revision:	date:	note:
P01	20190425	planning submission
P02	20210113	section 73 application

1.0 Proposed Changes to Condition 2

1.0 The Proposal

1.1 Amendment Item 1

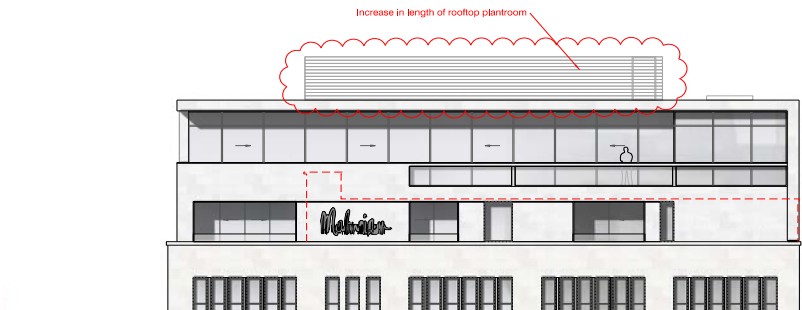
1.1.1 Replacement windows to all elevations with new slimline aluminium double glazed units to match existing, including slimline vent to window head.

- 1.1.2 The existing windows are single glazed units with non-thermally broken steel frames. Acoustically the units are not sufficient to meet the requirements of the proposed use and double glazed secondary glazing units have been considered to improve the acoustics to an acceptable level. Although a dew point calculation is not available it is anticipated that there will be significant condensation build-up between the thermally inefficient existing glazing and thermally efficient secondary glazing. Replacement glazing with sealed double glazed units in a slimline aluminium frame will provide all acoustic and thermal standards.

- 1.1.3 The replacement windows will match the existing window profile.
- 1.1.4 The service strategy for the hotel bedrooms requires an extract vent to each bedroom. This slimline vent is to be incorporated within the head of the new windows. The alternative would have been to penetrate the external fabric with a vent extract but was considered too intrusive on the elevation.

- 1.1.4 It is considered that this doesn't have a detrimental effect on the architectural appearance of the building.

1.3 Amendment Item 3

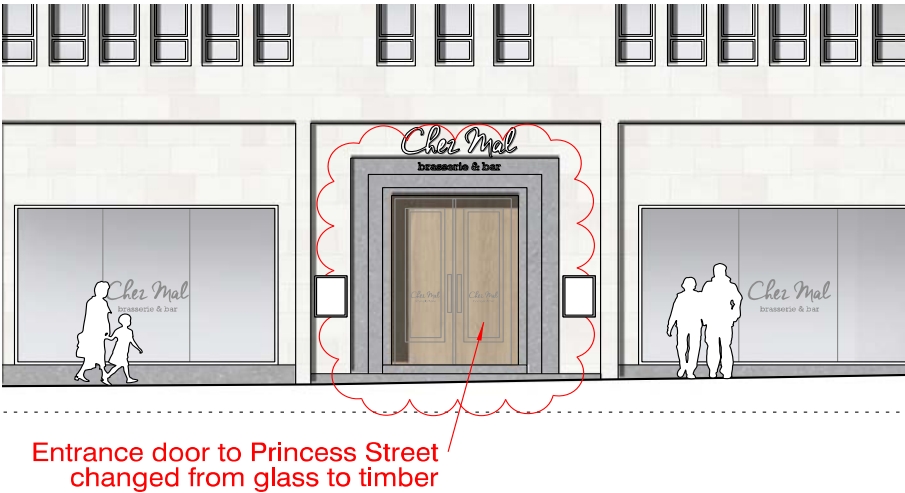
1.3.1 Omission of stone fins to Clarence Street elevation

- 1.3.2 The vertical stone fins have been omitted to provide a greater architectural distinction between new and existing.
- 1.3.3 It is considered that has a positive effect on the architectural appearance of the building.

1.5 Amendment Item 5

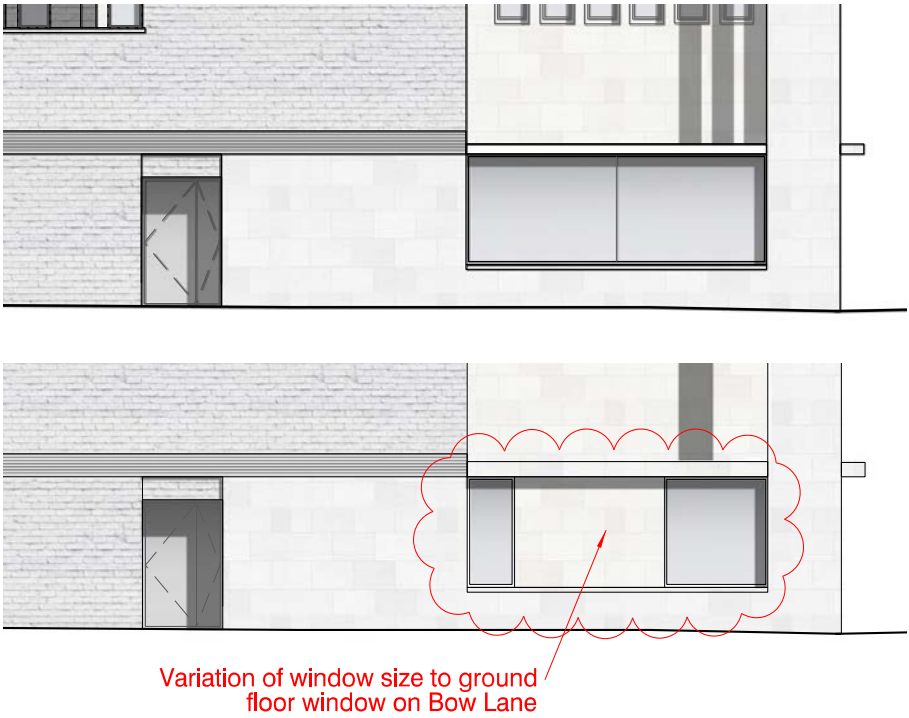
1.5.1 Variation of window size to ground floor window on Bow Lane

- 1.5.2 Due to detailed design development, it has been proposed to amend the large window into two asymmetrical windows with an infill of new stone cladding.
- 1.5.3 It is considered that this doesn't have a detrimental effect on the architectural appearance of the building.

1.6 Amendment Item 6

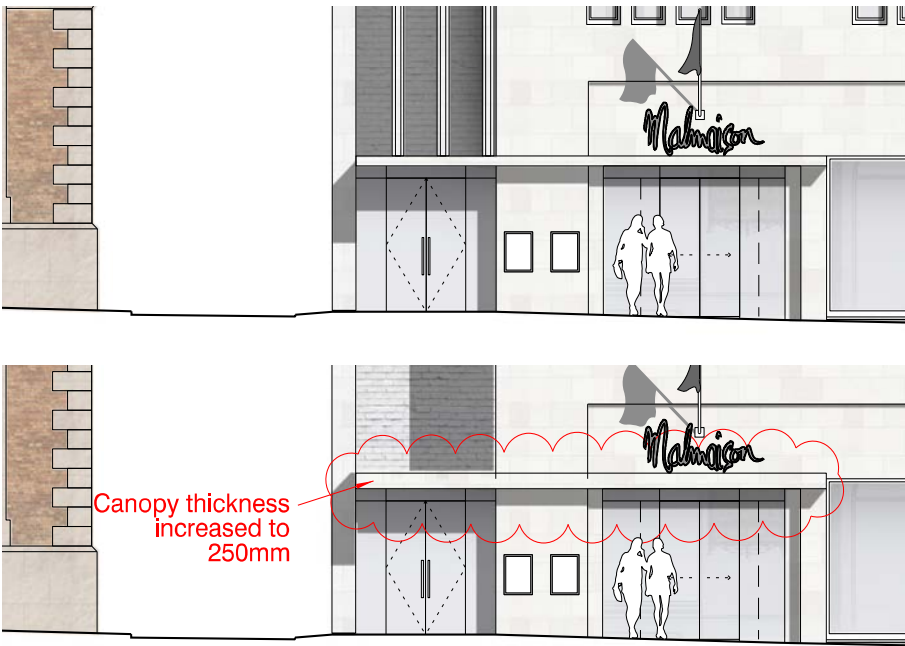
1.6.1 Addition of obscure glazing to top floor at high level

- 1.6.2 Due to detailed design development, it has been proposed to add obscure frosted glass to the glazing above the final transom of the top floor to conceal internal roof structure.
- 1.6.3 It is considered that this doesn't have a detrimental effect on the architectural appearance of the building.

1.0 Proposed Changes to Condition 2
Princess Street Elevation Comparison

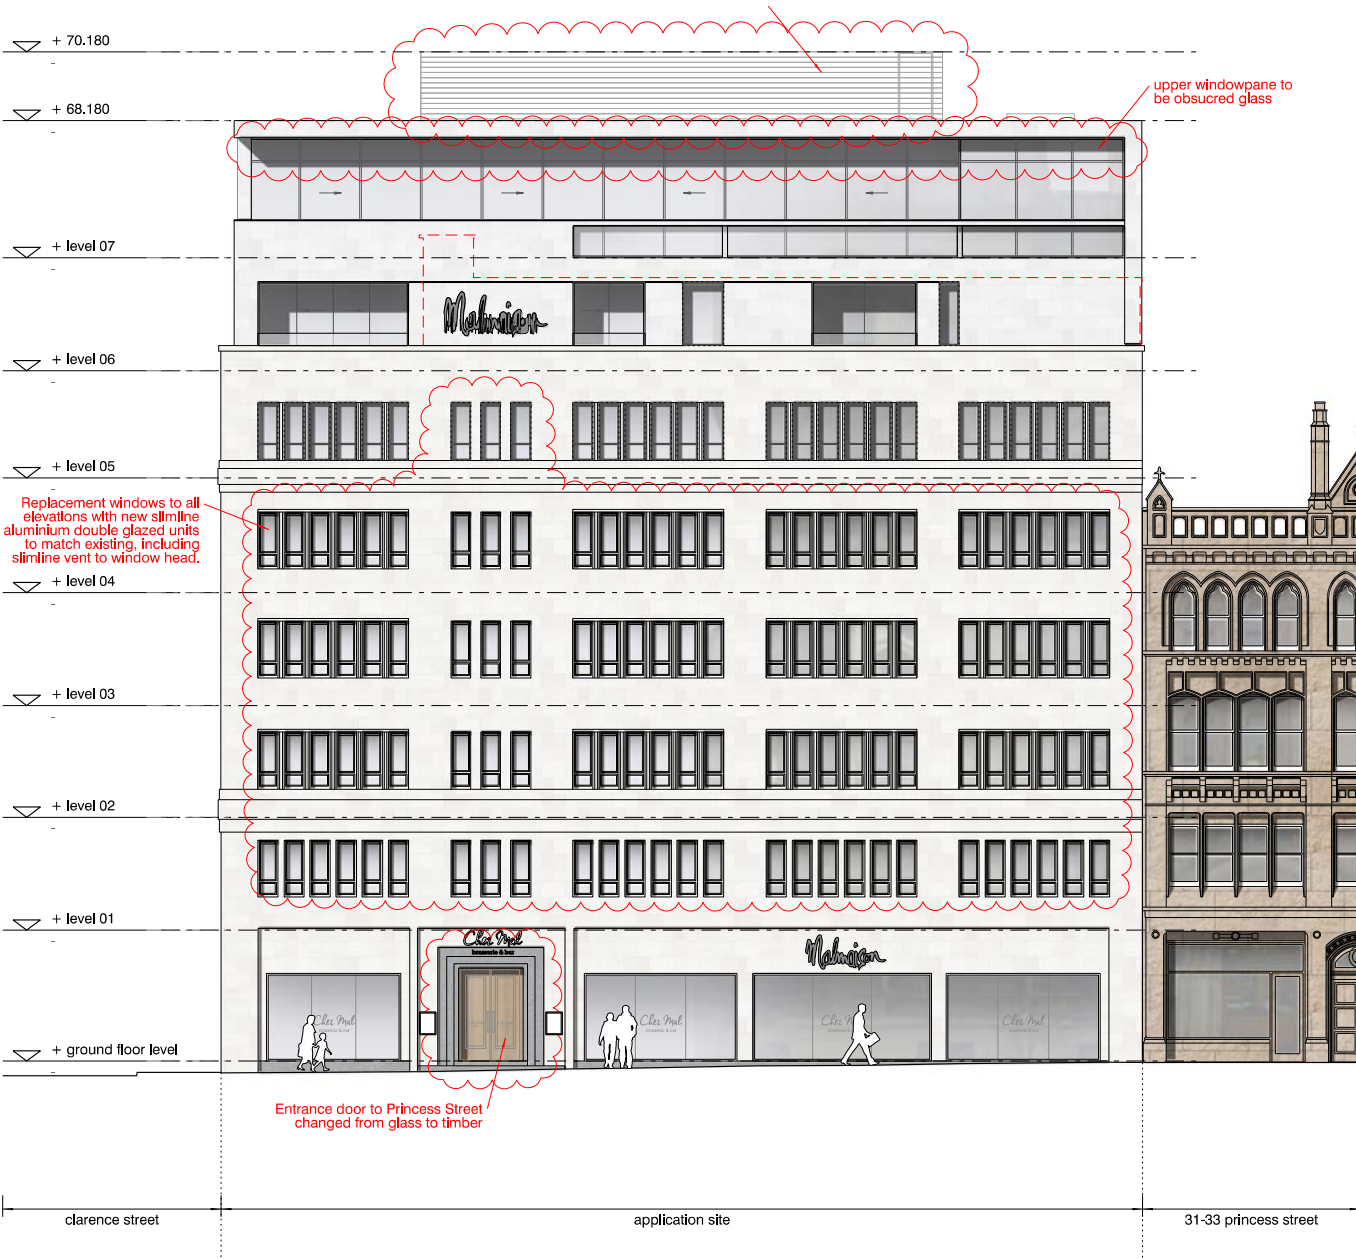
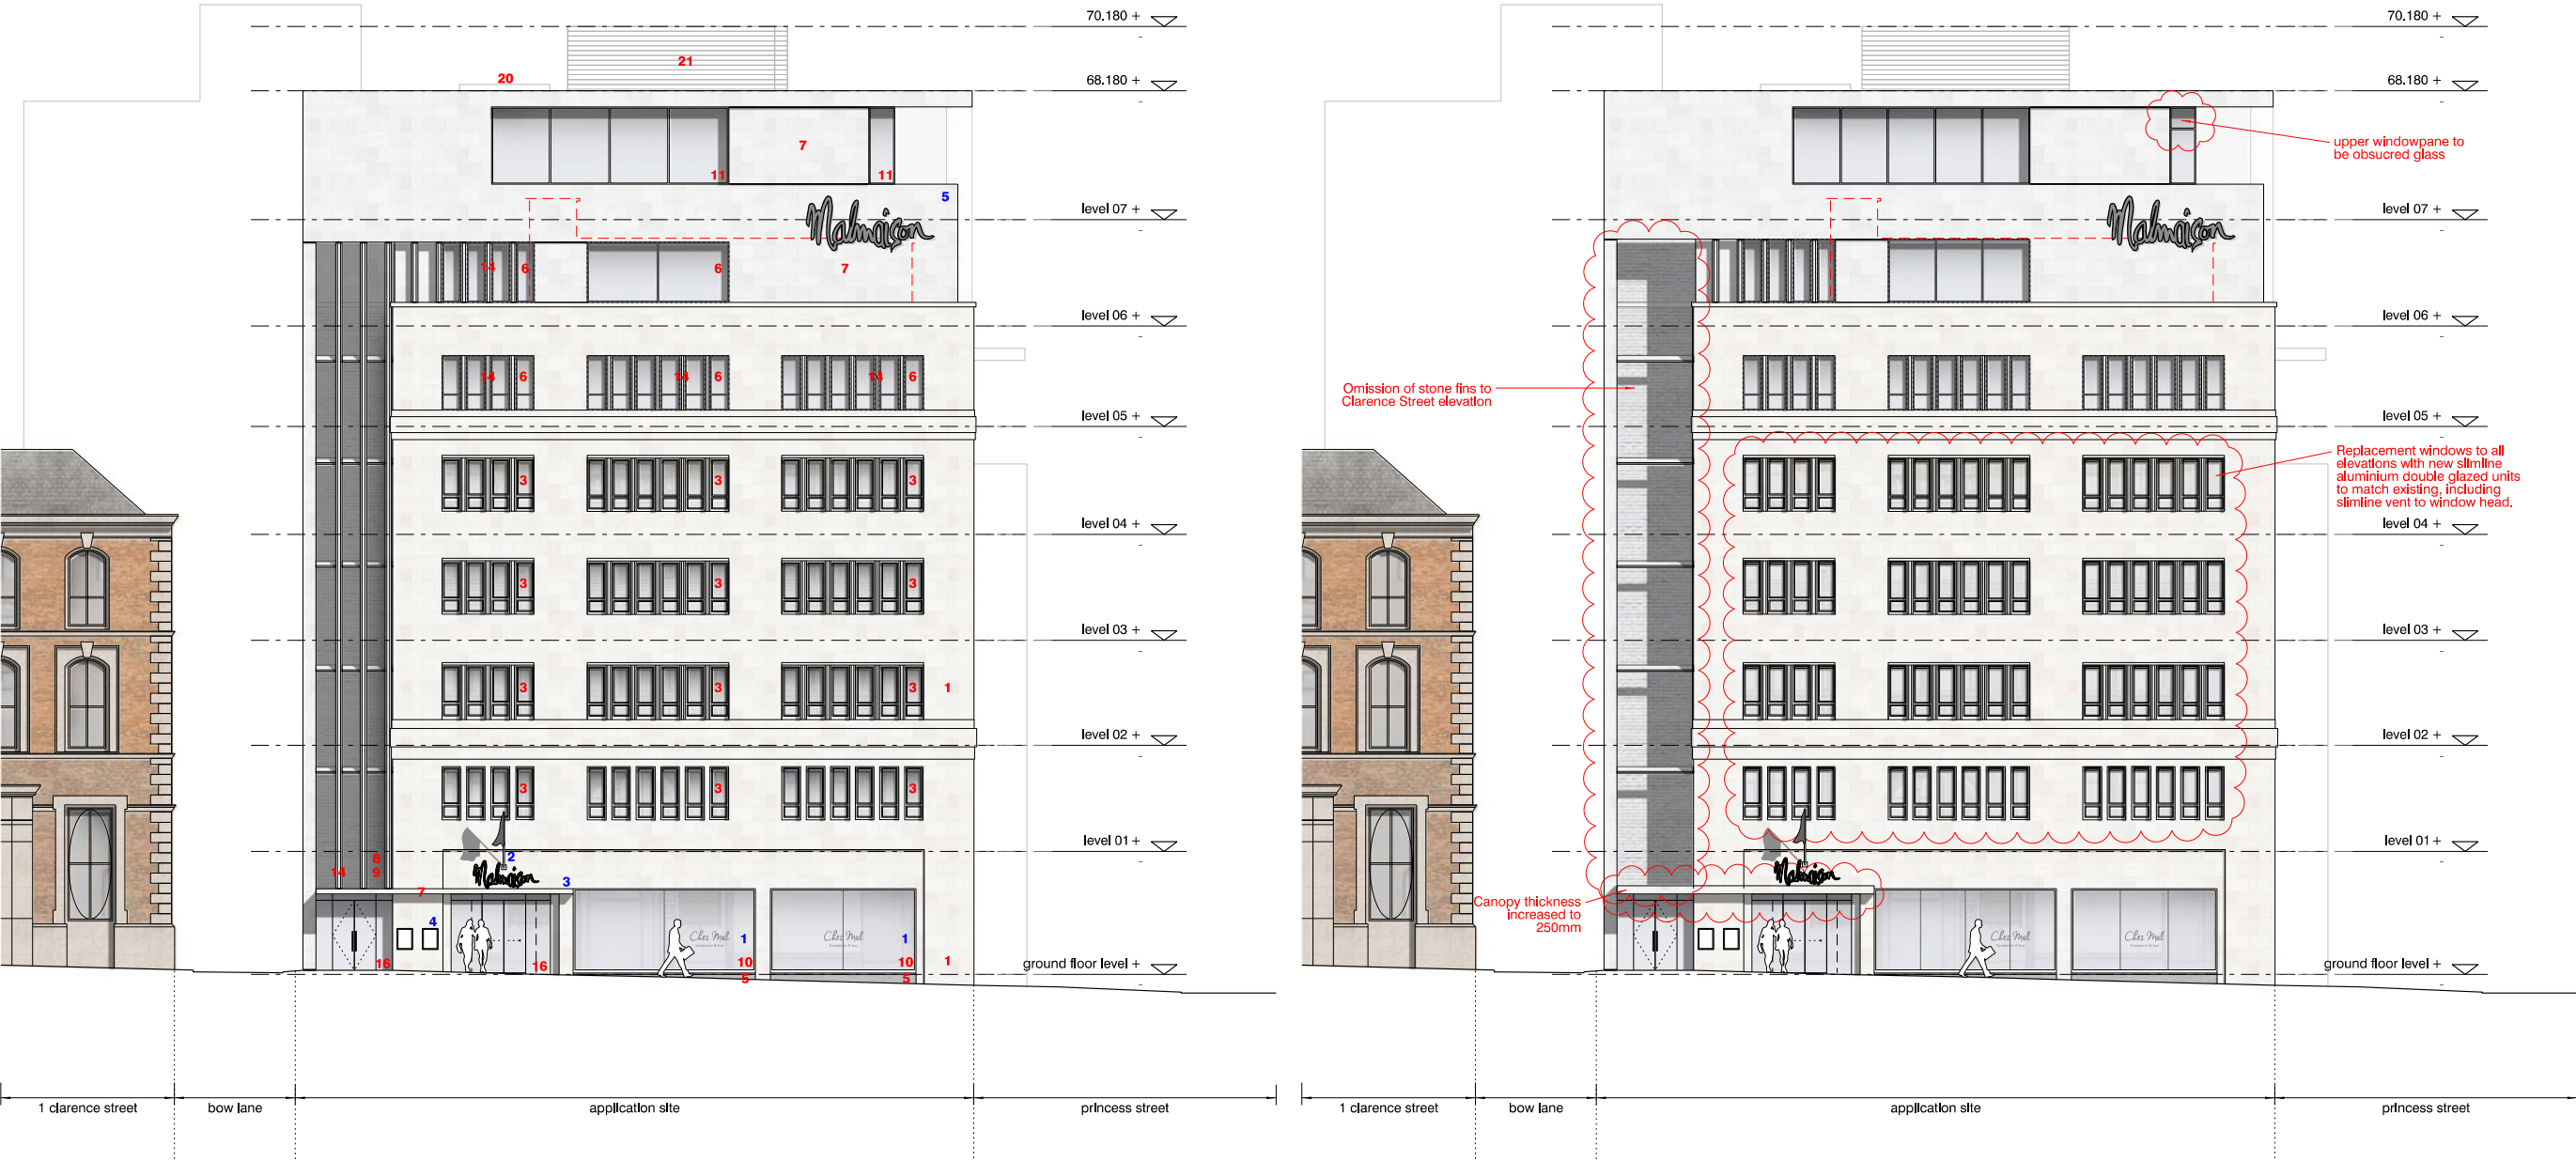
1.4.1 Entrance door to Princess Street changed from glass to timber.

- 1.4.2 To increase security and robustness it has been decided to change the material from glass to timber.
- 1.4.3 It is considered that this doesn't have a detrimental effect on the architectural appearance of the building.

1.0 Proposed Changes to Condition 2
Clarence Street Elevation Comparison

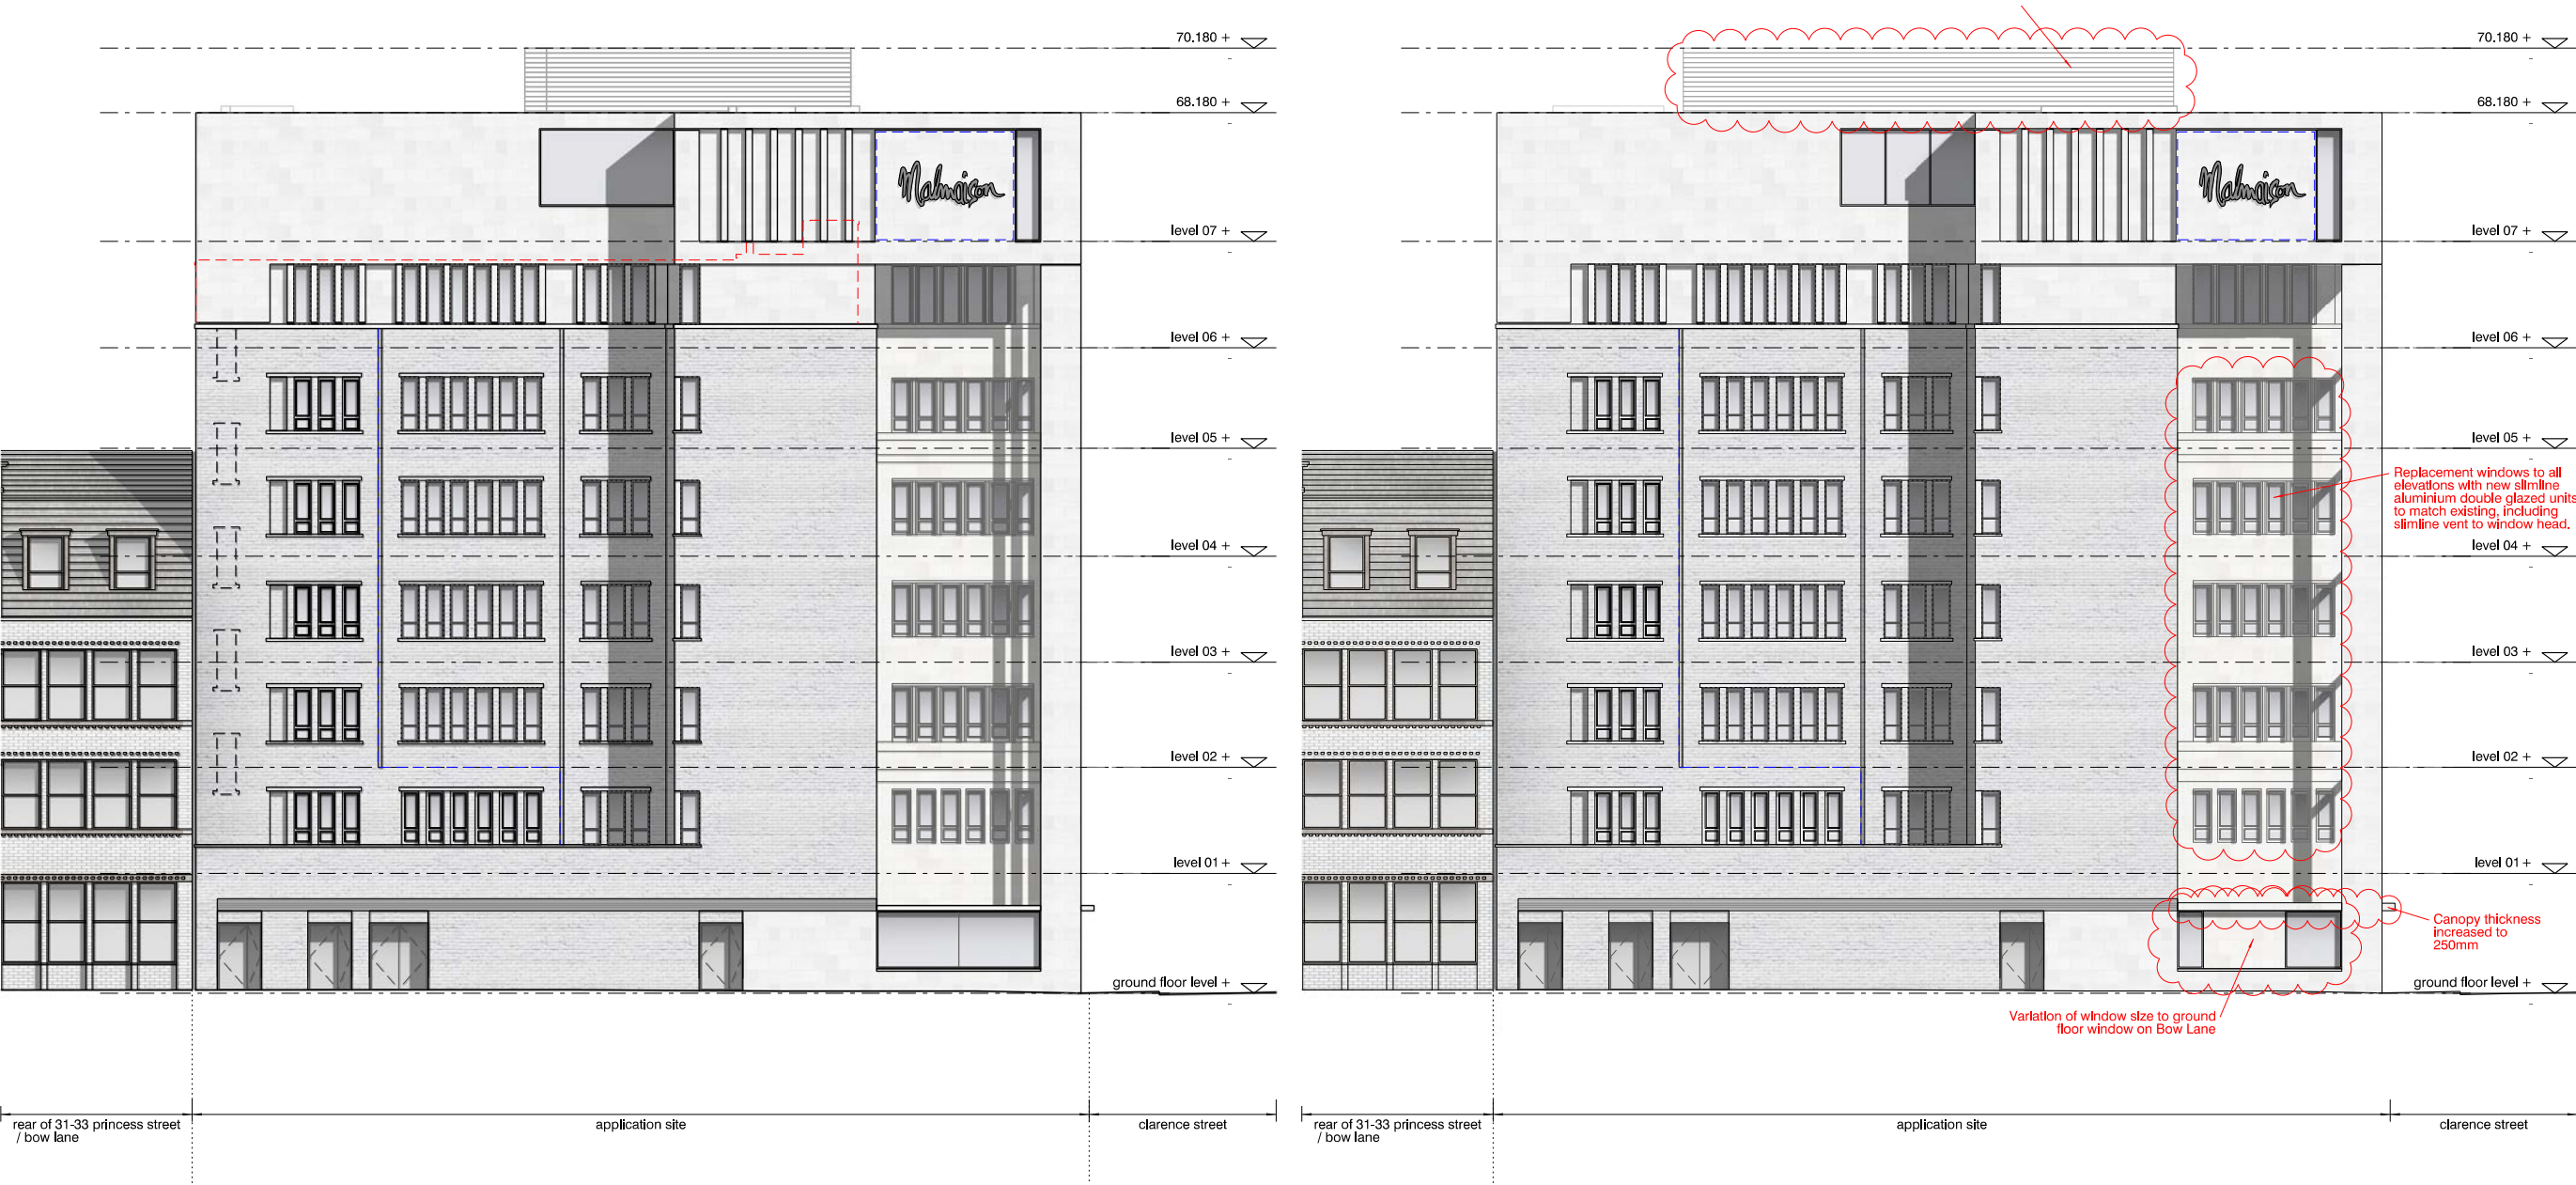
1.7.1 Variation of height of projecting canopy on Clarence Street

- 1.7.2 Due to detailed design development, it has been proposed to increase the depth of the canopy from 150mm to 250mm to conceal the canopy structure.
- 1.7.3 It is considered that this doesn't have a detrimental effect on the architectural appearance of the building.
